SUBJECT: GENERIC FOLLOWUP EVALUATION TO BOARD
NOTIFICATION BN-83-21 FOR B&W PLANTS

ENCLOSURE

Staff Evaluation

FIGURE 1

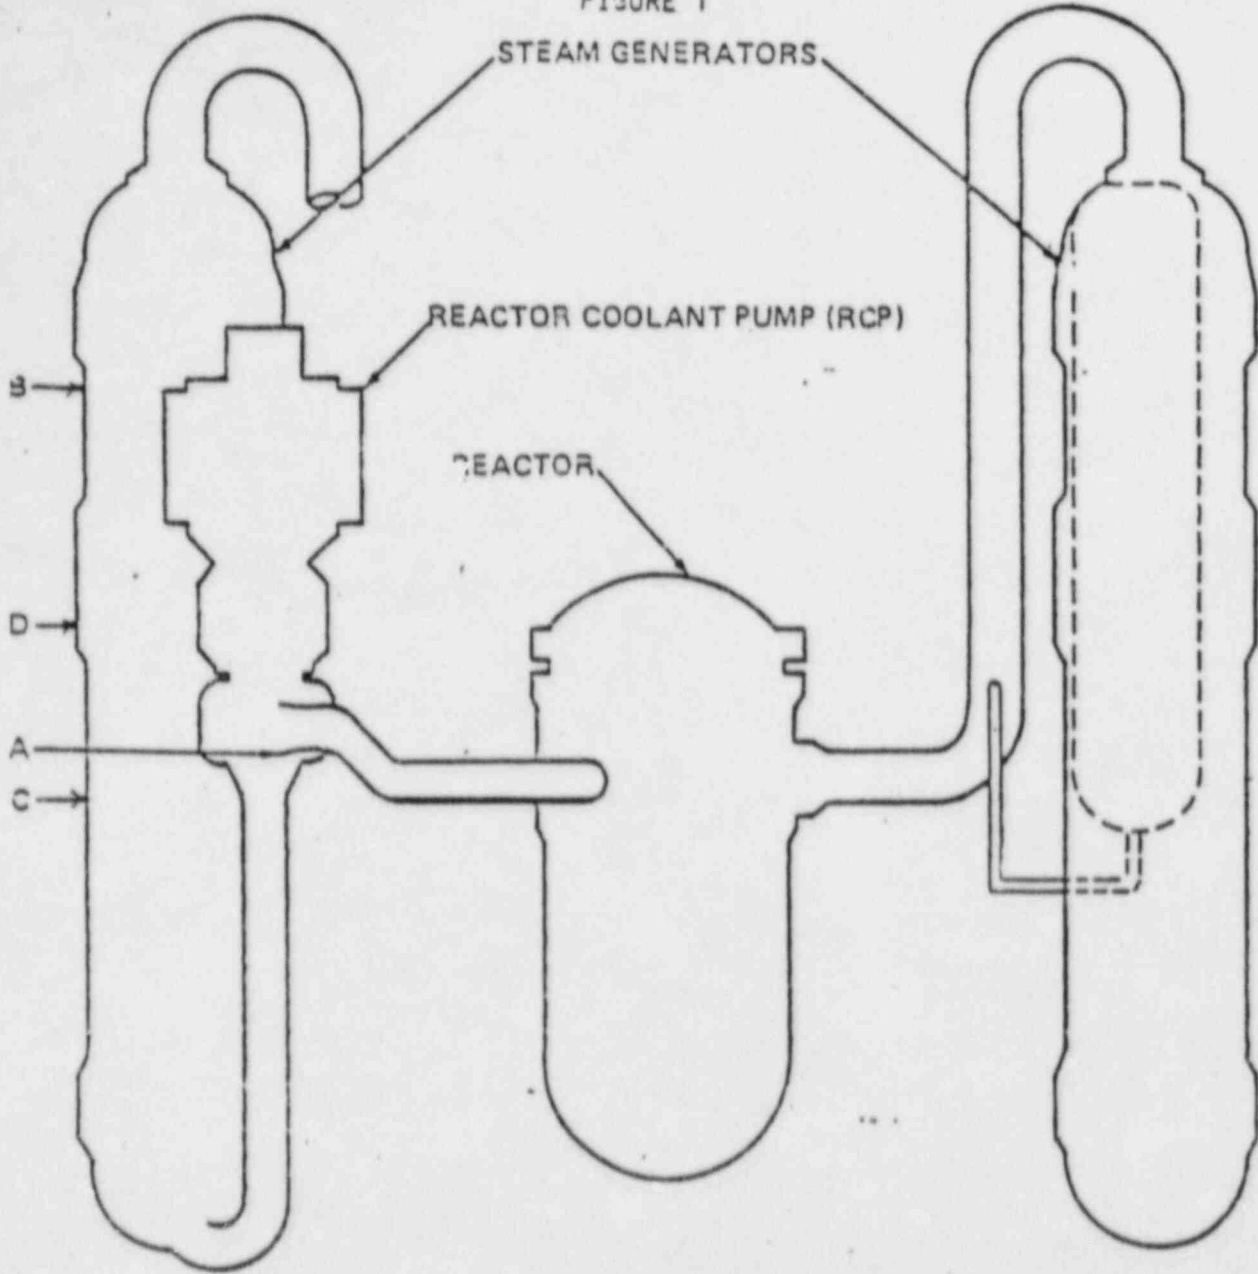
The issues raised by Dr. Lahey and Dr. Wallis are of concern only for B&W design plants with a lowered loop configuration. This arrangement is shown in Figure 1 and is applicable to ANO Unit 1, Oconee Units 1, 2 and 3; Crystal River Unit 3, TMI Units 1 and 2; Rancho Seco and Midland Units 1 and 2. Other plants designed by B&W have a raised loop configuration (see figure 2). This arrangement is utilized for Davis Besse Unit 1; Bellefonte Units 1 and 2 and WNP Unit 1. The Bellefonte and WNP Plants are further identified as 205 fuel assembly plants whereas all other B&W plants have 177 fuel assemblies.

Figure 6
RELATIONSHIP OF HIPI COOLING AND
BOILER CONDENSER COOLING FOR GENERIC
177 FALL PLANT

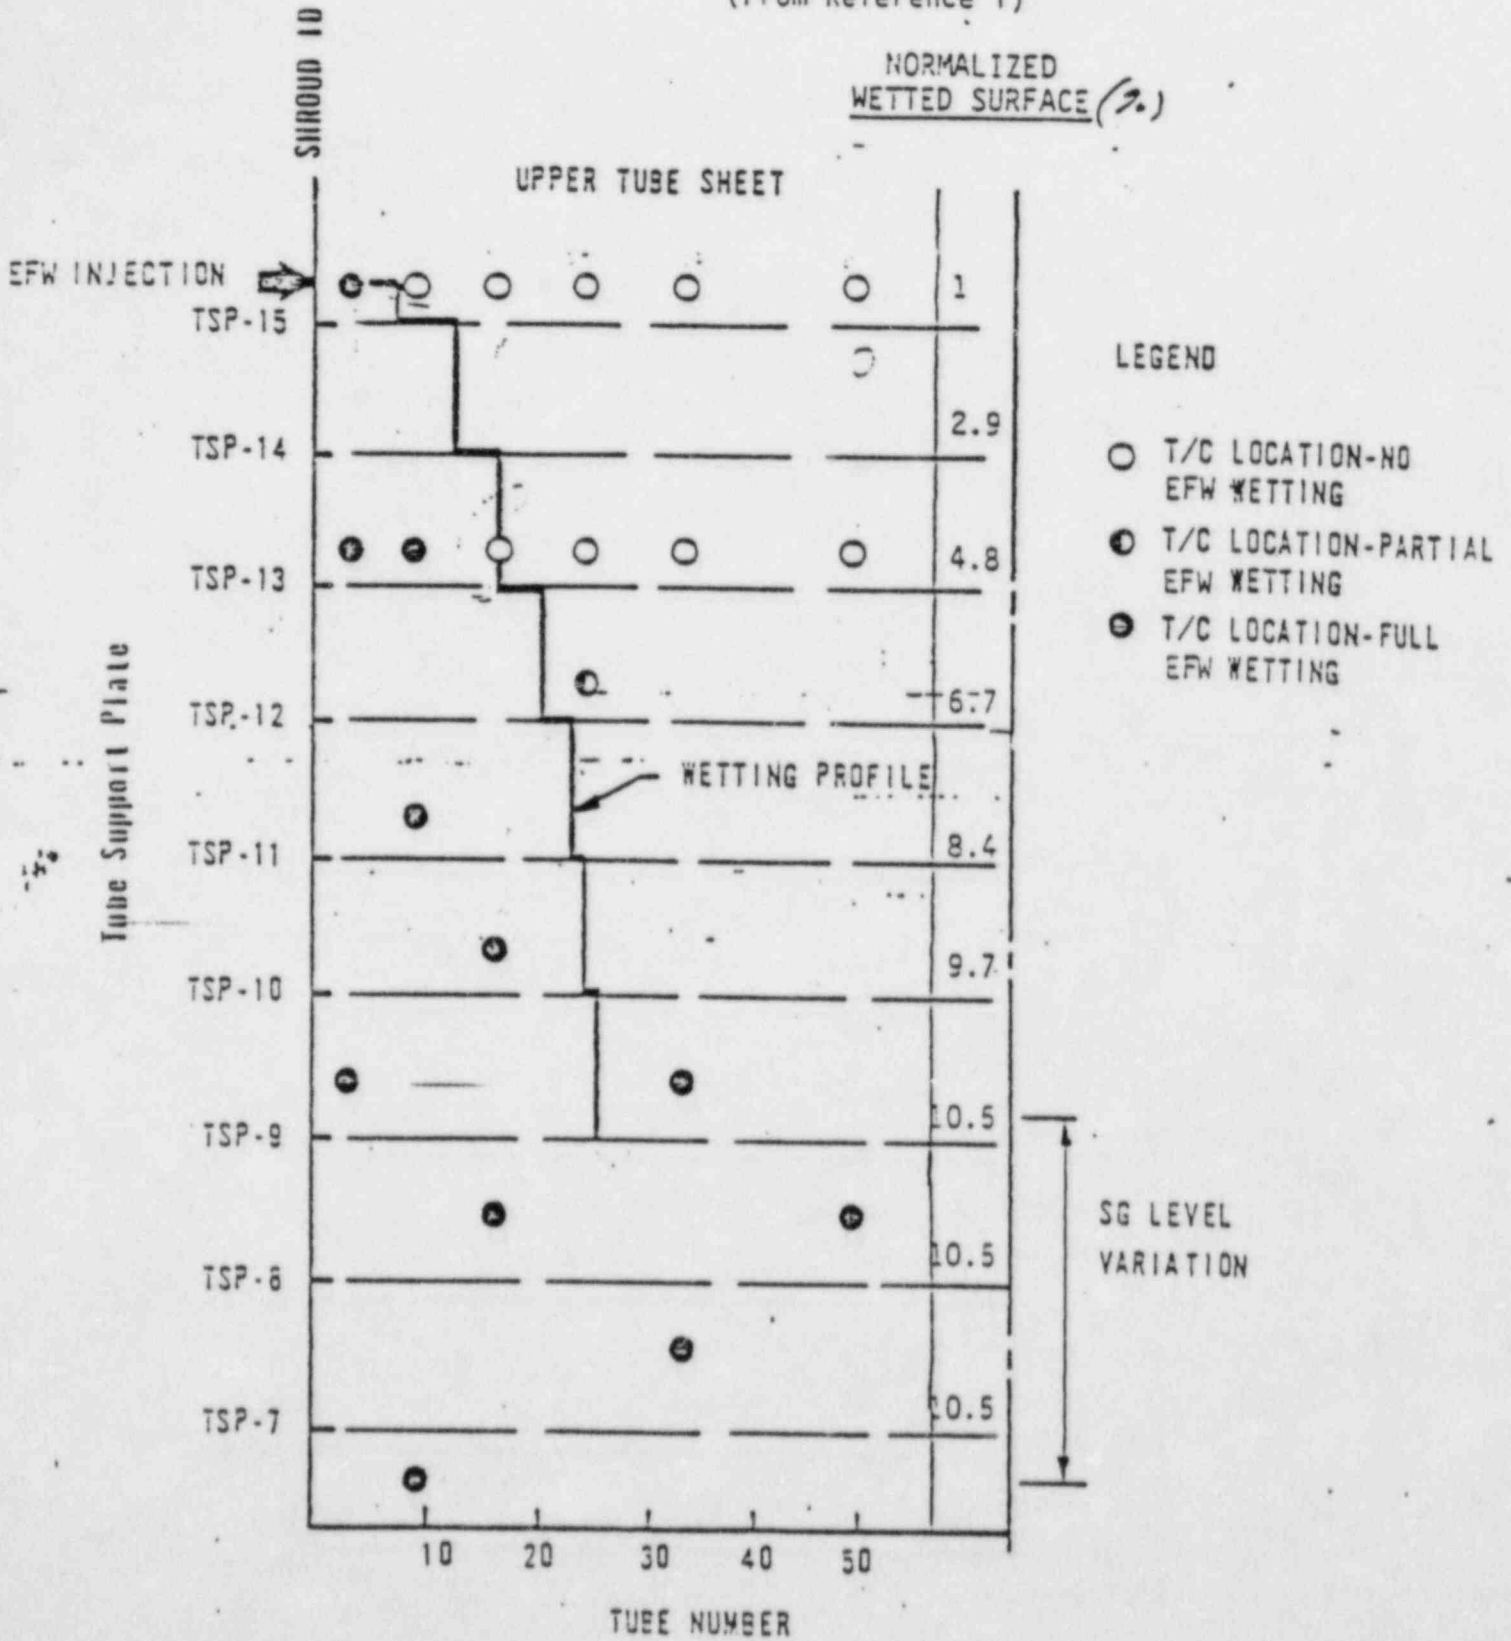
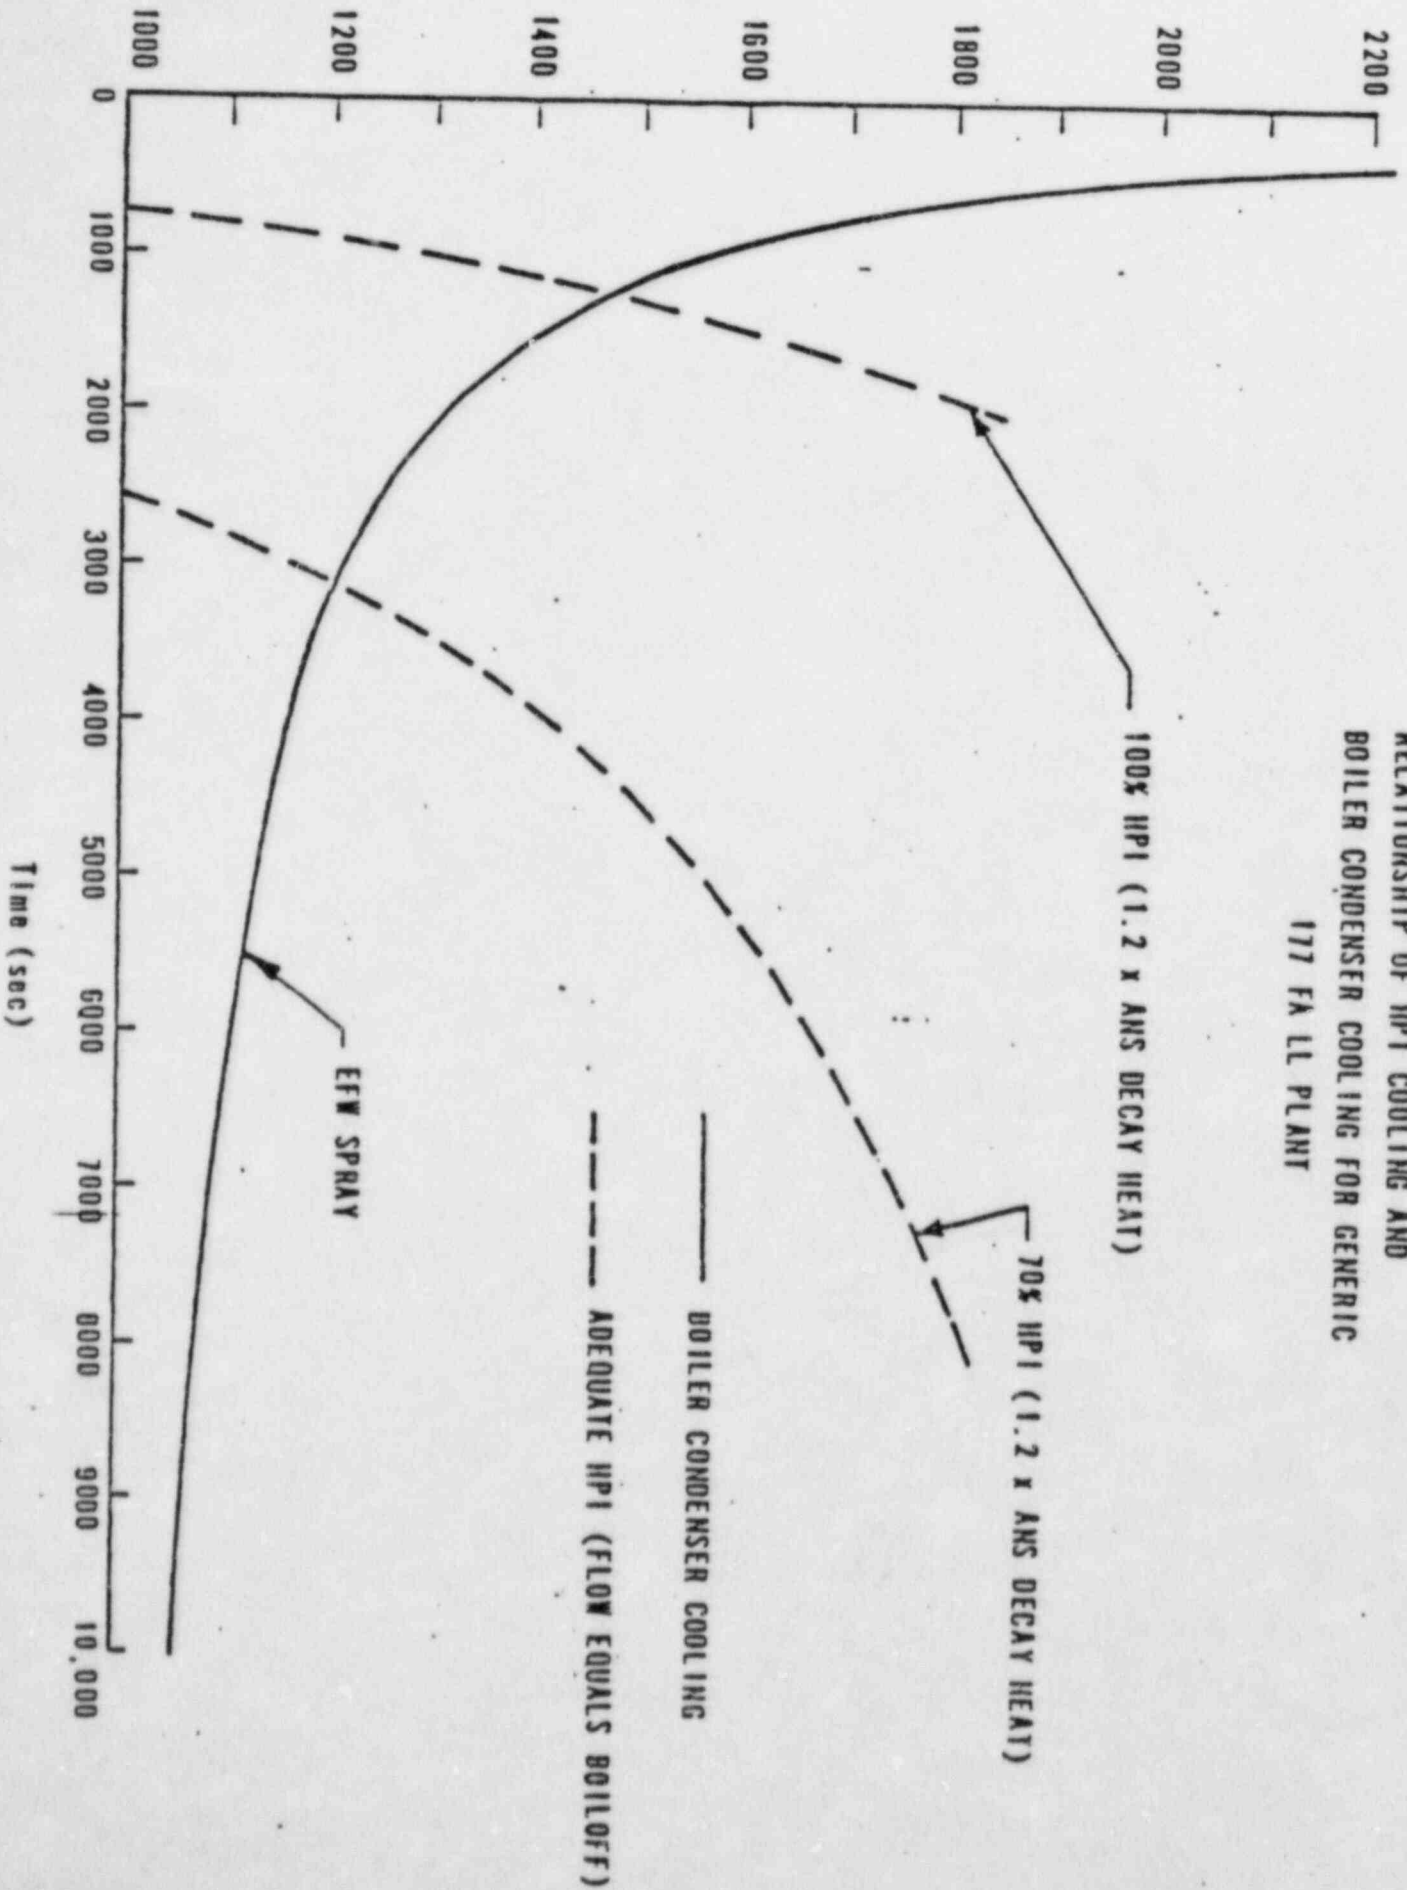
Figure 6, which is reproduced from Figure 3-2 of the B&W submittal, provides the results of mass and energy balances which demonstrate that even with reduced EFW penetration, the EFW spray is still sufficient to remove decay heat.

The solid curve, labeled EFW spray, represents the point at which the overall heat transfer rates from EFW spray, combined with the primary to secondary temperature difference at the indicated RC pressure, can remove all of the decay heat at the indicated time. This curve is basically the energy balance requirement. The dashed lines represent the points at which the HPI flow can match the core boiloff at the prevailing pressure. The significance of this curve is that prior to any core uncovery, the break must uncover, and discharge steam. The source of the steam is the core boiloff; therefore the dashed line represents the point at which HPI flow will match break flow (the mass balance). The intersection of the two curves is the point at which both all decay heat can be removed by EFW spray and HPI can fully make up all mass loss through the break. These occur for all times beyond about 1000 seconds for the 100% HPI case and beyond 3000 seconds for the 70% HPI case.* It is therefore only necessary to show that core
